Changes for DM3730 vs OM3P3530:

Title			
OPEN PANDORA			
Size	Number	Mainboard	
C			
Date	March 1, 2011	Drawn by	Michael Weston
Filename		Sheet	1 of 8

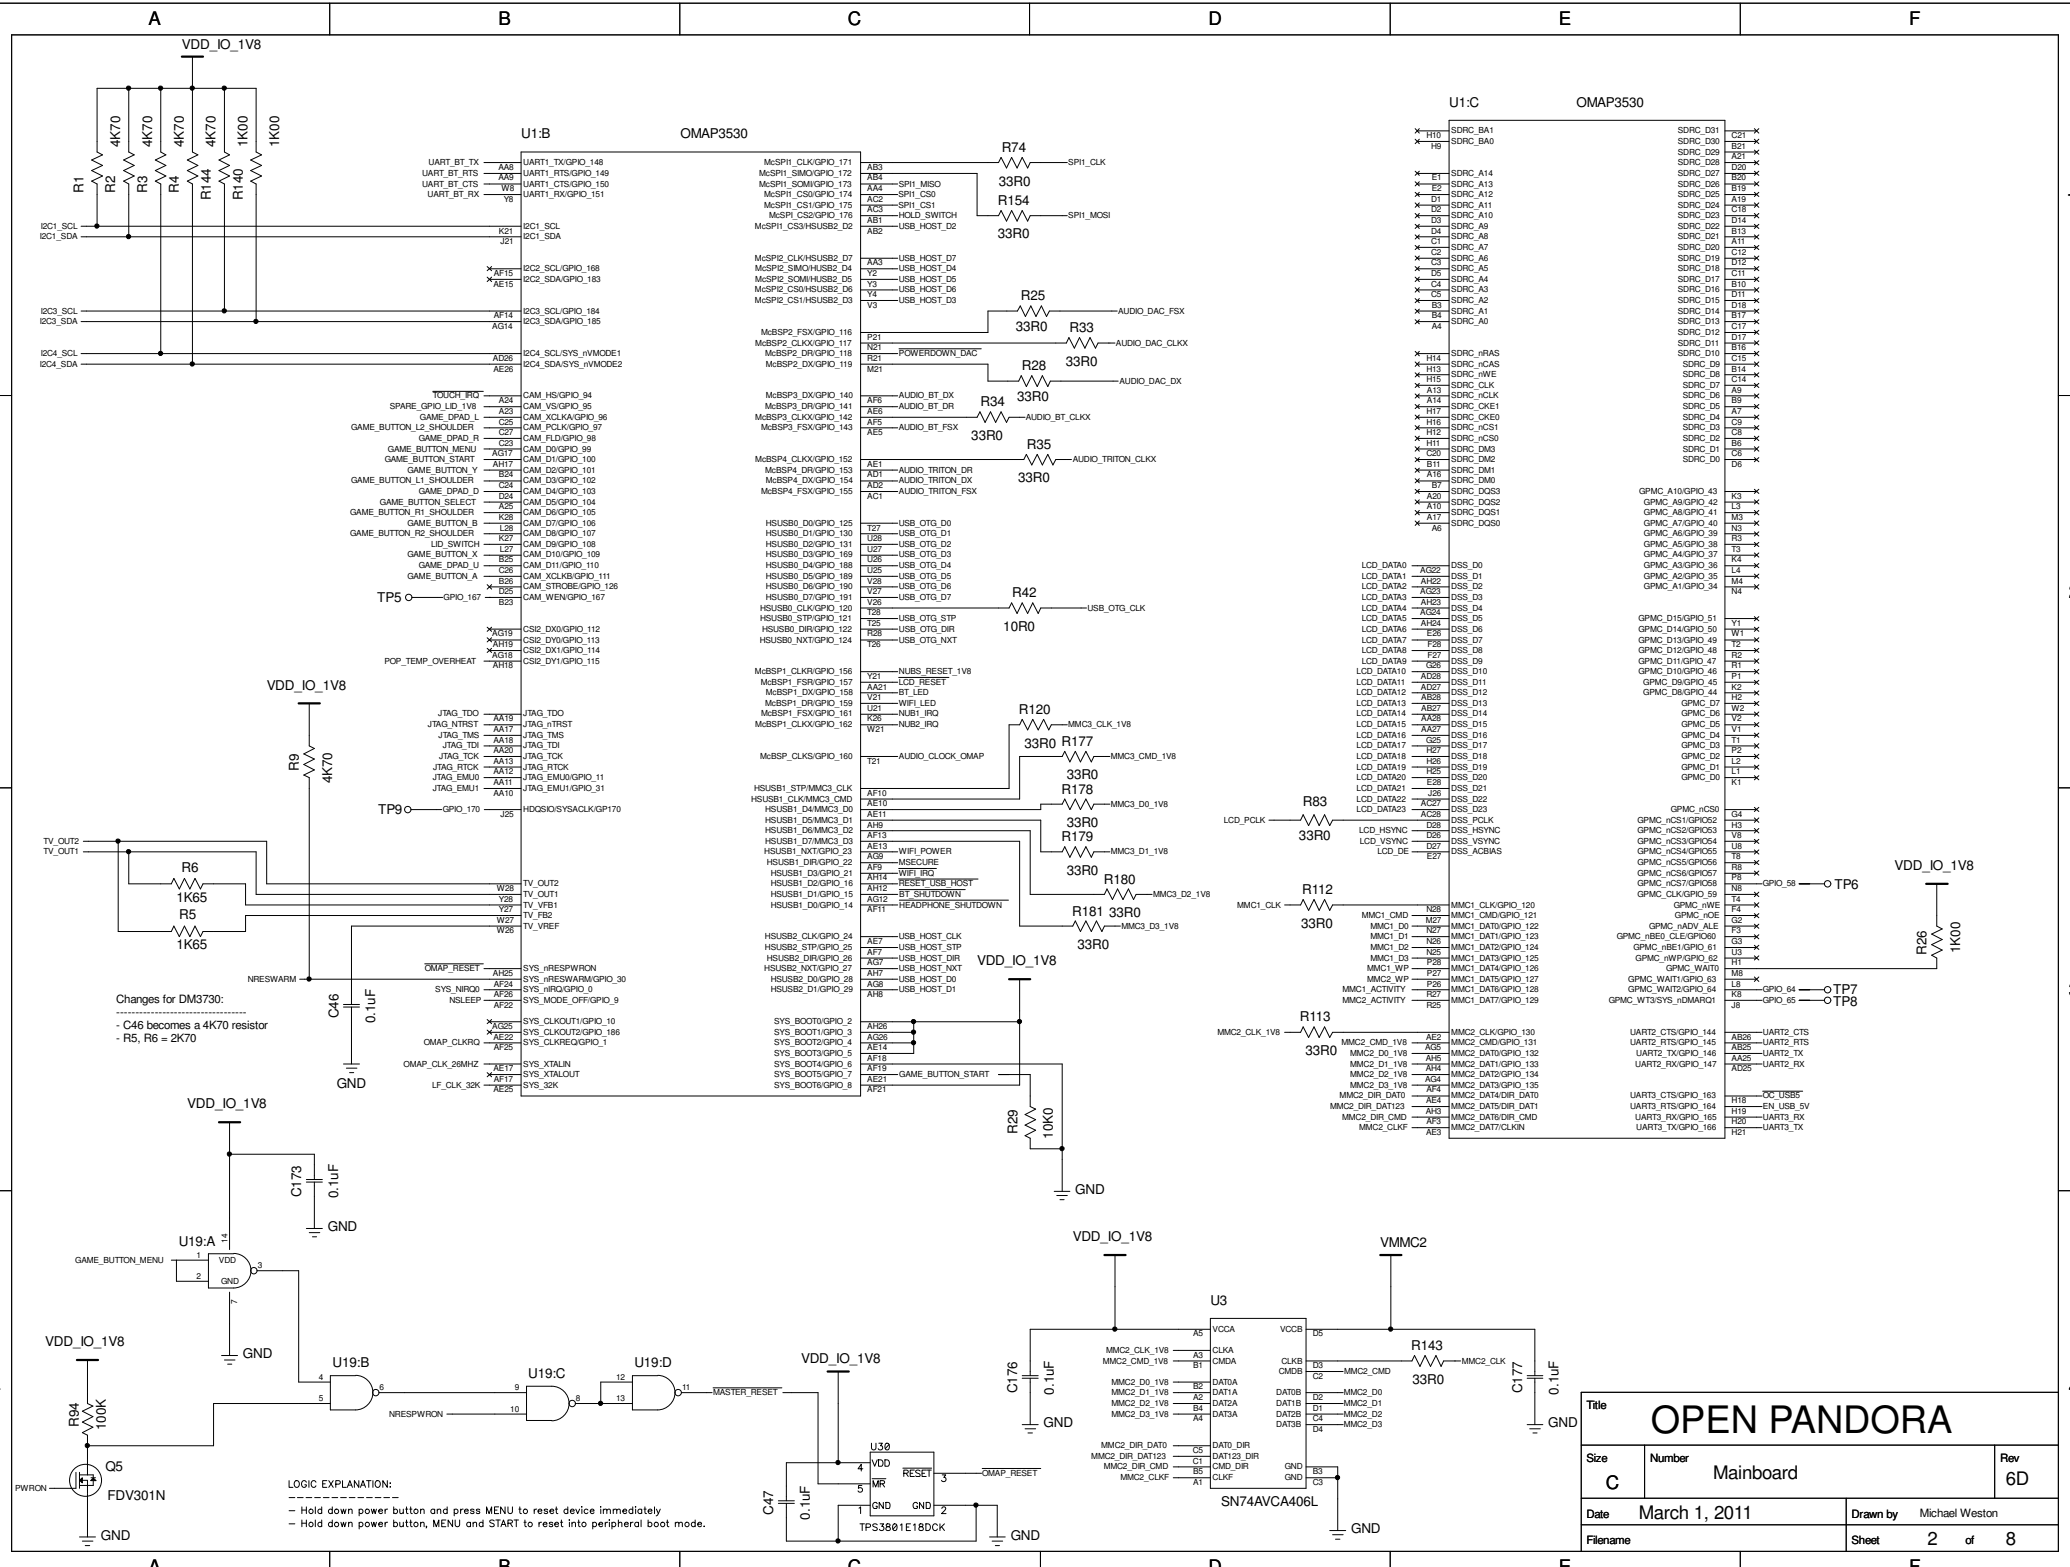
- C1, C2, C3, C5, C6, C7 = 1uF
- C19, C20, C21, C22, C23, C24, C25, C132, C135 = 0.7uF (use 1uF)
- C10, C11, C12, C14, C15, C16, C17, C18, C184, C186 = 1uF
- C45 = 1uF
- C219 = 1uF (populate)
- R46 = 100K
